UNITED STATES PATENT AND TRADEMARK OFFICE

APPLICATION NO.	FILING DATE	FIRST NAMED INVENTOR	ATTORNEY DOCKET NO.	CONFIRMATION NO.
08/851,465	05/05/1997	EDGAR C. ROBINSON	INT21246	5986
21118 7590 08/17/2011 JOHN RUSSELL UREN 2431 Simpson Road Richmond, BC V6X 2R2 CANADA				
EXAMINER SUERETH, SARAH ELIZABETH				
ART UNIT		PAPER NUMBER		
3749				
MAIL DATE		DELIVERY MODE		
08/17/2011		PAPER

Office Action Summary**Application No.**

DETAILED ACTION

Segment of Fig. 1 of Nutten (the examiner has added the lead arrows and text appearing below).

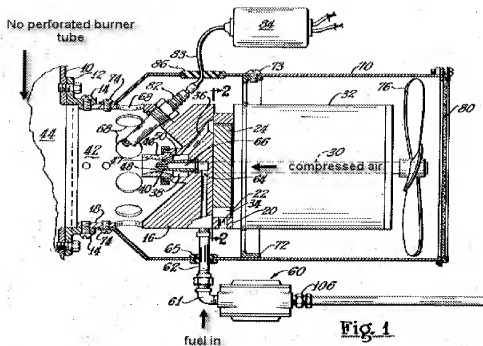
As discussed and above and illustrated in the segments of applicant's Fig. 5A and Nutten's Fig. 1, Nutten discloses all the elements of applicant's claim 1 with the exception of a burner tube with a perforated outer surface rendering the burner an "infrared burner." However, the examiner has pointed to Patrick showing the use of a perforated burner tube in the burner art forming an "infrared burner." The following is a segment of Fig. 7 of Patrick which is disclosed as being an infrared liquid fuel burner (*next page*):

Rotated Copy of Applicant's Fig. 5A (the examiner has added the lead arrow and "perforated burner tube" text appearing below).

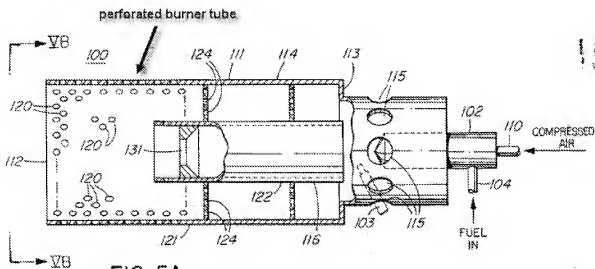
3. Claims 1-8 are rejected under 35 U.S.C. 112, first paragraph, because the specification, while being enabling for the teaching of a perforated burner tube downstream of the nozzle, does not reasonably provide enablement for the limitation that the perforations are located "immediately adjacent" the nozzle. Figure 5A, for example, shows perforations (120) at a distance spaced from the nozzle (102). The specification does not enable any person skilled in the art to which it pertains, or with

6. As discussed above, claim 1 has been amended to include the recitation of perforations which are located "immediately adjacent" the nozzle. However, it is unclear from the claim if the perforations are intended to be the openings shown in the sides of the burner tube (120), the perforations in spacer plates (124), or the perforations supplying air to the nozzle (115).

7. For Examination purposes, the examiner has regarded the claims as referring to the perforations in the sidewalls of the burner tube (120), but applicant is requested to clarify if the claim is intended to read on the perforations in the sideways spacing plates (124) or at the nozzle outlet (115).

Segment of Fig. 7 of Patrick (the examiner has added the lead arrow and text appearing below).

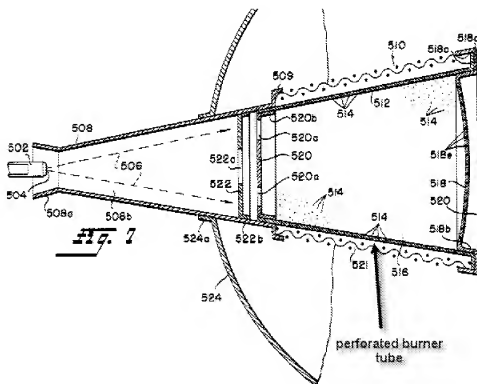
However, Patrick is cited to remedy this deficiency. Patrick teaches a liquid fuel fired burner that is considered analogous art to both applicant's invention and Nutten. The liquid fuel burner of Patrick is expressly noted to be an infrared burner (see col. 1, lines 8-9). This infrared burner includes a burner tube that includes a burner tube that is perforated that is typical of infrared burner assemblies (see Fig. 7 showing a burner tube 510 that includes perforations 514 and 518e in outer surfaces 512 and 518).

As seen in the above Figures, and noted in the above 112 rejections, the scope of the new claim limitation that the burner tube has perforations extending immediately adjacent the nozzle is unclear. However, Patrick is regarded to teach this limitation, as Patrick shows a liquid fuel nozzle (502) upstream of a perforated burner tube (514). To the extent the perforated burner tube of applicant is "immediately adjacent" the fuel nozzle, the Patrick burner tube is regarded as being "immediately adjacent" to the nozzle, as they show the same configuration.
